2.0 SITE CHARACTERISTICS

Chapter 2, “Site Characteristics,” of the Turkey Point Units 6 and 7 combined license (COL) final safety analysis report (FSAR) addresses the geological, seismological, hydrological, and meteorological characteristics of the Turkey Point Units 6 and 7 site and vicinity, in conjunction with present and projected population distribution and land use and site activities and controls.

2.0.2 Summary of Application

Figure 2.4.12-1. Simulated piezometric levels across the plant area (Layer 1-4 correspond to the four layers: Miami Limestone, Key Largo Limestone, Freshwater Limestone, and Fort Thompson Formation in the numerical model).

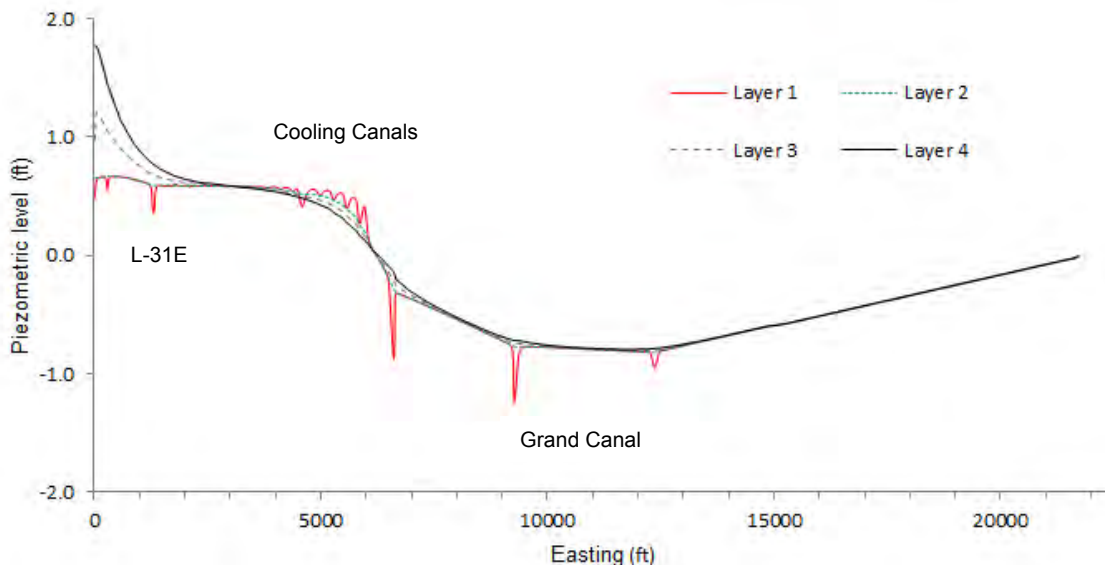
To assess the influence of water use in the plant on the regional groundwater flow directions, the staff took an east-west cross section from the applicant's 3-dimensional groundwater model grid (row 260, east-west across the plant) and constructed a 2-dimensional groundwater model using a publicly available spreadsheet tool (Anderson and Bair 2001). The boundary conditions in the east and west were modeled as fixed head boundaries. The results (Figure 2.4.12-1) confirm that the regional hydraulic gradient from the west (inland) to the east (ocean) is controlled by the water levels in the cooling and L-31E irrigation canals. The vertical gradient is even smaller and the variations near the canals are significant only in the first layer (Miami Limestone) and dampen out with depth in the underlying layers 2–4 (Key Largo Limestone, freshwater limestone, and Fort Thompson Formation, respectively). These results show that as long as the water level in the canals is maintained at the designed level, water use at the plant is not expected to alter the regional groundwater flow direction (from the west to the east, and from underground to the ground surface). This is due to the relatively permeable subsurface geologic formations and small hydraulic gradient at the site.

The staff performed an independent confirmatory analysis of the potential impact of the maximum water level of 22.5 ft (6.9 m) in the MWR on the subsurface potentiometric head distribution at Turkey Point Units 6 and 7, as described below. The staff calculated the lateral head losses from the MWR through the 3 ft (0.9 m) thick concrete floor and then through 100 ft of the Miami Limestone aquifer. According to Darcy's law, discharge rate, q , is estimated as $q = k_1 \Delta h_1 / L_1 = k_2 \Delta h_2 / L_2$, and $\Delta h = \Delta h_1 + \Delta h_2$, where k , Δh , and L are the hydraulic conductivity, head loss, and length, and subscripts 1 and 2 stand for the concrete layer and aquifer layer, respectively. It can be derived that $\Delta h_1 / \Delta h = (L_1 / k_1) / (L_1 / k_1 + L_2 / k_2)$. Using conservative values for k_1 and k_2 , i.e., $k_1 = 10^{-8}$ cm/s (Turkey Point Units 6 and 7 COL FSAR 2.4.13.1.3.1 assumes 8.25×10^{-9} cm/s, which is an order of magnitude higher than that of intact concrete in included reference) and $k_2 = 10^{-4}$ cm/s (less than the smallest calibrated value in Turkey Point Units 6 and 7 COL FSAR Table 2CC-205), the calculated head loss in the concrete floor is 22.4 ft (6.8 m). This result indicates that most of the head is expected to be lost over the concrete floor of the MWR due to its low permeability. Therefore, the water in the MWR, even at maximum level, is not expected to raise the groundwater table under Turkey Point Units 6 and 7 significantly (less than a few feet, comparing with the 23.5 ft (7.2 m) design elevation). Accordingly, the staff's review of the studies and reports described above and the staff's evaluation of the applicant's analysis described above confirmed that the applicant's description of the groundwater flow directions is acceptable and adequate.

Figure 2.4.12-2. Maximum groundwater mounding under steady-state flow condition with aquifer thickness of 25 ft (7.6 m) (freshwater limestone as the aquitard).

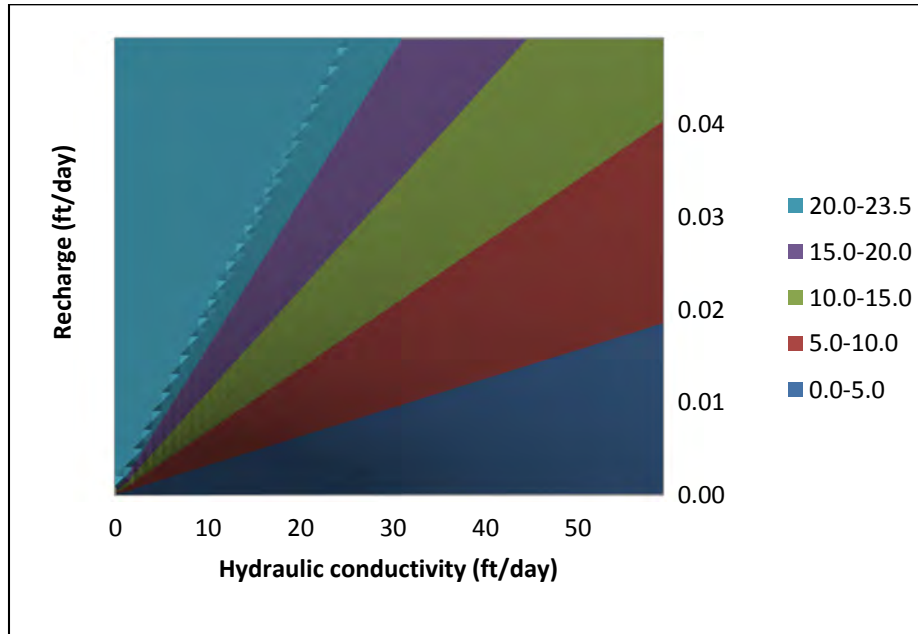
Let $R = 1,330$ ft (405 m), and h_{max} is dependent on the hydraulic conductivity, recharge rate, and aquifer thickness. A hydraulic conductivity of less than 3-4 ft/day (0.9-1.2 m/day) is necessary for the mounding to be over the 23.5 ft (7.2 m) maximum groundwater level (Figure 2.4.12-2) with a recharge equal to the annual precipitation $w = 3.79$ ft/year = 0.01 ft/day and an assumed aquifer thickness of 25 ft (freshwater limestone as the aquitard). As the vertical hydraulic conductivity of the surficial Biscayne aquifer is approximately 15 ft/day (4.6 m/day) (Turkey Point Units 6 and 7

COL FSAR Revision 2, Table 2.4.12-205), the maximum water level is not likely to be exceeded under steady-state flow conditions, given expected conductivity of the fill material used to build up the island. Accordingly, the staff finds that that the maximum groundwater level meets the criteria of the Design Control Document (DCD) of the AP1000 at a maximum of 2 ft (0.6 m) below grade.

Figure 2.4.12-3. Groundwater mounding calculated using Basak (1982) for the 72-hour probable maximum precipitation of 55.7 in.

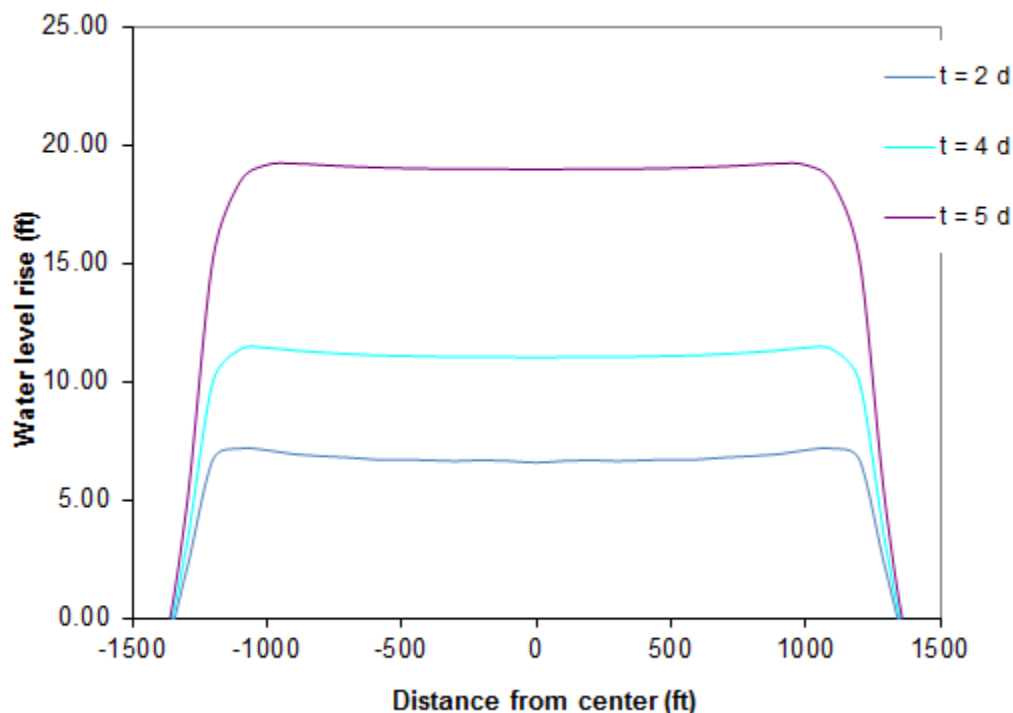
The staff also estimated maximum groundwater elevation under a transient flow scenario. The 72-hour probable maximum precipitation of 55.7 in. for areas of 10 mi² or less in the Florida peninsula was considered. The approximate analytical solution by Basak (1982) was used to calculate the groundwater table mounding. The results (Figure 2.4.12-3) show that the maximum water level of 23.5 ft (7.2 m) is not likely to be exceeded, even when the maximum precipitation occurs for 5 days ($R = 1,330$ ft (405 m), $k = 15$ ft/day (4.6 ft/day), $b_0 = 50$ ft (15.2 m), and specific yield = 0.3). Even though the Basak (1982) solution is accurate only for a small mounding level (say 5 ft (1.5 m) of a 25 ft (7.6 m) thick unconfined island aquifer) and for a hydraulic conductivity greater than the recharge rate, the possible maximum mounding level would be expected to be much less than 23.5 ft (7.2 m) for an expected recharge rate less than 1 ft/day, and hydraulic conductivity greater than 10 ft/day (Figure 2.4.12-4). Accordingly, the staff finds that that the maximum groundwater level under a transient flow scenario meets the criteria of the Design Control Document (DCD) of the AP1000 at a maximum of 2 ft (0.6 m) below grade.

design level. In the staff's analysis, no coverage of ground surface with pavement was assumed. The results of the staff analysis confirmed that the extent of pavement did not influence groundwater mounding

Figure 2.5.1-9. Cunningham (2015) Seismic Sag structure

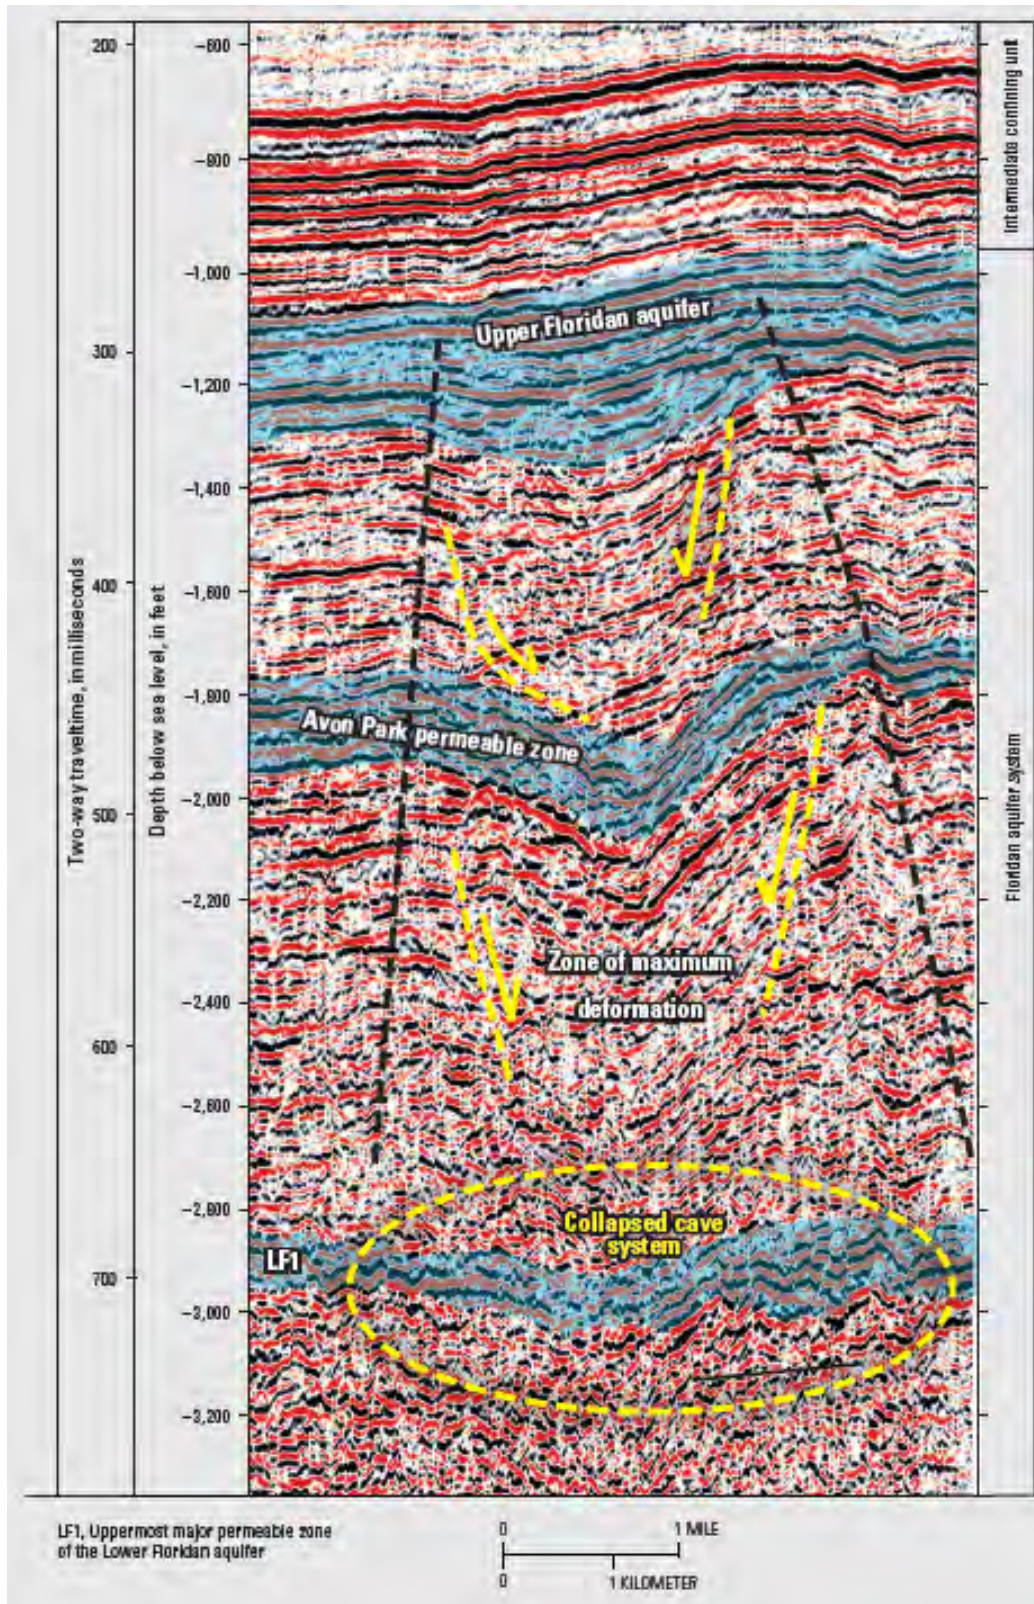
The staff independently sought out and reviewed many publications pertaining to the Turkey Point Units 6 and 7 COL FSAR review and found a recent short paper (Cunningham et al., 2012) that reveals normal and reverse faults in Biscayne Bay and the shelf margin, within 11.3 km (7 mi) of the site, based on approximately 210 km (130 mi) of high-resolution marine seismic data. One of these faults is identified on 5 seismic lines and extends about 16 km (10 mi), striking N, NE (Figure 2.5.1-10). The authors interpret this fault as a vertical normal fault offsetting the top of the Arcadia Formation. The staff notes that the fault projects directly toward the Turkey Point Units 6 and 7 site. Because the fault appears to offset the top of the Arcadia Formation, the age of movement might be as young as early Pliocene (5.3 Ma). The staff also notes that this tectonic structure is not included in the Turkey Point Units 6 and 7 COL FSAR. In RAI 81, Question 02.05.01-36, the staff asked the applicant to discuss this tectonic feature with respect to the Turkey Point Units 6 and 7 site, and integrate the information into the regional tectonic setting. The staff also asked the applicant to address the possibility that the fault is strike-slip and finally to address the possibility that this fault underlies the Turkey Point Units 6 and 7 site, and what impact if any does this have on potential surface deformation.

In a May 19, 2015, response to RAI 81, Question 02.05.01-36 (ADAMS Accession No. ML15156A616), the applicant cited a recent USGS Scientific Investigations Report (Cunningham, 2015) that includes additional information about the fault identified in Biscayne Bay. Cunningham (2015) extends the fault, as uncertain, an additional 30 km (20 mi) northward through a data gap to connect with a possible offset identified in seismic profiles at the Miami-Dade North District Boulder Zone Water Field. Cunningham (2015) now interprets this fault as strike-slip with a characteristic normal, dip-slip component (up to the east), with typically about 12 m (40 ft) of vertical separation. The youngest faulted strata are the Arcadia Formation (Miocene age). The author interprets the top of Peace River and Tamiami formation (Pliocene) strata as unfaulted. Movement on the fault is thus interpreted to be within mid Miocene to early Pliocene, meaning no movement in the last 3.6 Ma.

Figure 2.5.1-11. Miami Terrace anticline from Cunningham, 2015 (Source: Turkey Point Units 6 and 7 COL FSAR Figure 2.5.1-395)

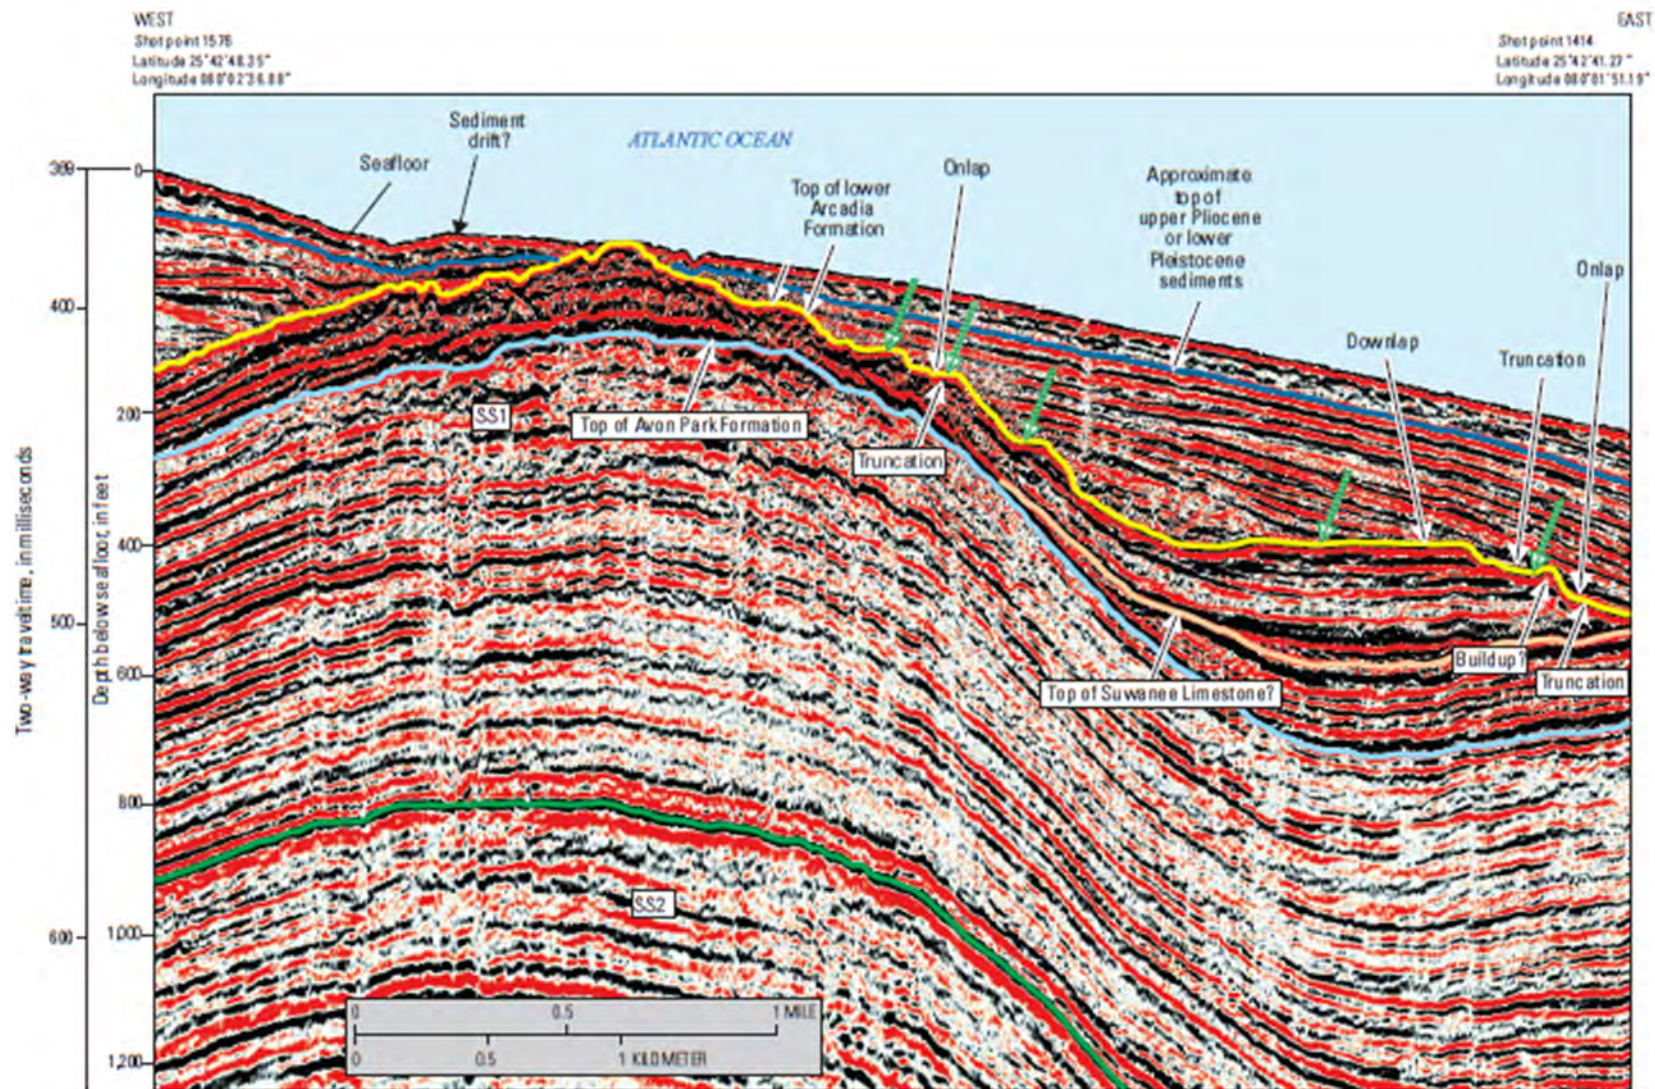
The staff independently reviewed Cunningham (2015) and observed a tectonic anticline, located east of Miami, on the Miami Terrace, about 48.2 km (30 mi) from the Turkey Point Units 6 and 7 site that has not been previously discussed in the Turkey Point Units 6 and 7 COL FSAR. Cunningham (2015) clearly shows a tectonic anticline with uplifted truncated seismic reflections assigned to the top of the lower Arcadia Formation (Figure 2.5.1-11). Horizontal, buried wave-cut terraces on the flank of the anticline indicate uplift and erosion of the lower Arcadia Formation followed by deposition of late Pliocene or early Pleistocene-age sediments. The author suggests that this compression event is consistent with the timing of tectonic movement of the Santaren anticline, also considered a potential Quaternary structure. The staff also notes that this young tectonic structure is close to the Turkey Point Units 6 and 7 site and has not been previously characterized in the Turkey Point Units 6 and 7 COL FSAR. Therefore, in RAI 85, Question 02.05.01-38, the staff asked the applicant to discuss this tectonic feature with respect to the Turkey Point Units 6 and 7 site, to integrate the feature into the regional tectonic setting for the Turkey Point Units 6 and 7 site COLA, and, finally, to discuss how this feature might affect the PSHA at the Turkey Point Units 6 and 7 site in light of sensitivity analyses completed for the Santaren Anticline and the Walker's Cay fault, 274 and 320 km (170 and 200 mi) from the Turkey Point Units 6 and 7 site, respectively.

In addressing the staff's question regarding the Miami Terrace structures' effect on the Turkey Point Units 6 and 7 site's PSHA (RAI 85, Question 02.05.01-38), the applicant cited Appendix A to RG 1.208 definition of a capable tectonic source and stated that because the uppermost deformed strata observed in the anticline and reverse faults is the Oligocene to Miocene Arcadia Formation, the structures are not considered to be capable tectonic features. The applicant pointed out that there is only one Emb 2.70 earthquake in the project Phase 1 earthquake catalog, including dependent events, located approximately 10 km away from the Miami terrace structures. Thus, there does not appear to be an association of seismicity with these structures. Therefore, the applicant stated that the reverse faults and fold reported by Cunningham et al. (2012) and Cunningham (2015) are not capable tectonic sources and would not affect, and should not be included in, the PSHA for the Turkey Point Units 6 and 7 site.

Figure 2.5.1-12. Santaren anticline and faults from Jo et al., 2015.

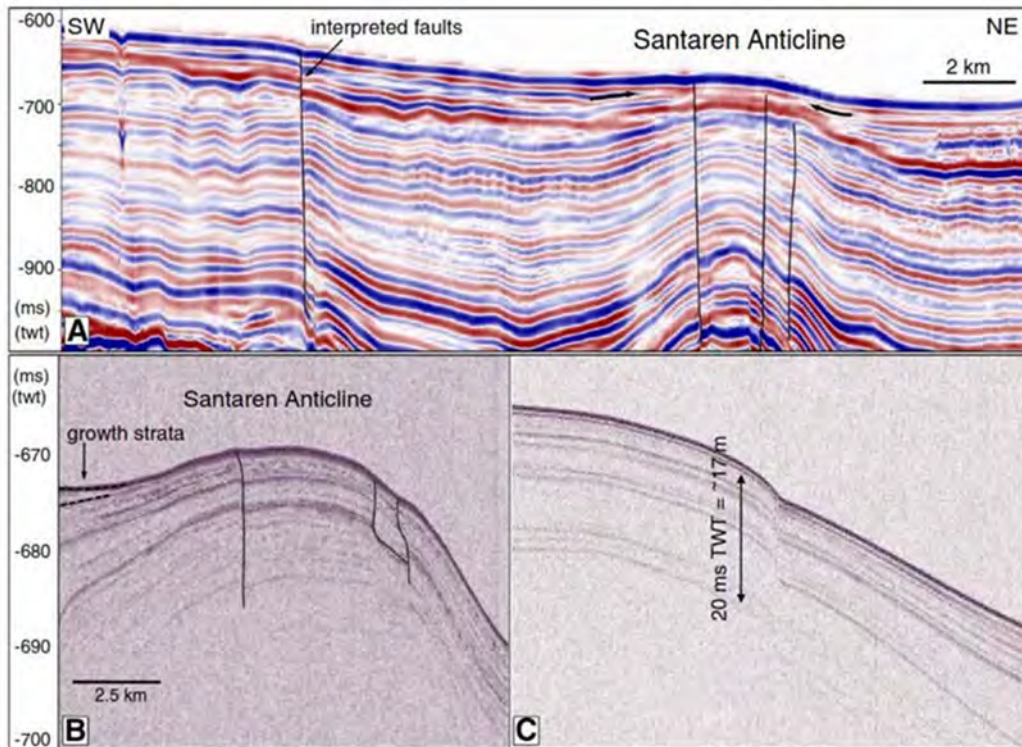
The staff reviewed Kula (2014) and notes that the author includes interpretations regarding possible Quaternary tectonic faults along the western bank of the northern Santaren Channel (northeast of the Cay Sal Bank). High resolution seismic reflection, multibeam bathymetry and sub-bottom parasound profiles reveal Quaternary-aged tectonic structures in the Santaren Channel and the Straits of Florida within about 50 mi of the Turkey Point Units 6 and 7 site (Figure 2.5.1-13). Although there is no seismicity in the area beneath Cay Sal Bank and the Santaren Channel, distinct seafloor scarps suggest recent and significant displacement on faults imaged on seismic reflection. In RAI 81, Question 02.05.01-34, the staff asked the applicant to discuss and integrate these tectonic features into the regional tectonic setting for the Turkey Point Units 6 and 7 site. The staff asked the applicant to provide an analysis of how a northward extension of the Cuban Fold and Thrust Belt terrane with associated Quaternary fault displacement and seafloor scarps on at least two faults impacts the site seismic hazard assessment and seismotectonic boundaries. The staff also asked the applicant to update interpretations of the Santaren Anticline

The applicant stated that while a fault has yet to be imaged in the core of the relatively symmetrical Santaren anticline, this structure is a candidate for a potential seismic source because fold deformation appears to be Quaternary in age (Jo, 2013; Jo et al., 2015) and a fold uplift rate was determined for this structure (Masaferro et al., 2002). New high-resolution seismic data and subbottom profiles illustrate Quaternary growth strata and steeply dipping secondary faults associated with the Santaren anticline, further suggesting ongoing deformation of the anticline (Jo et al., 2015) (Figure 2.5.1- 12).
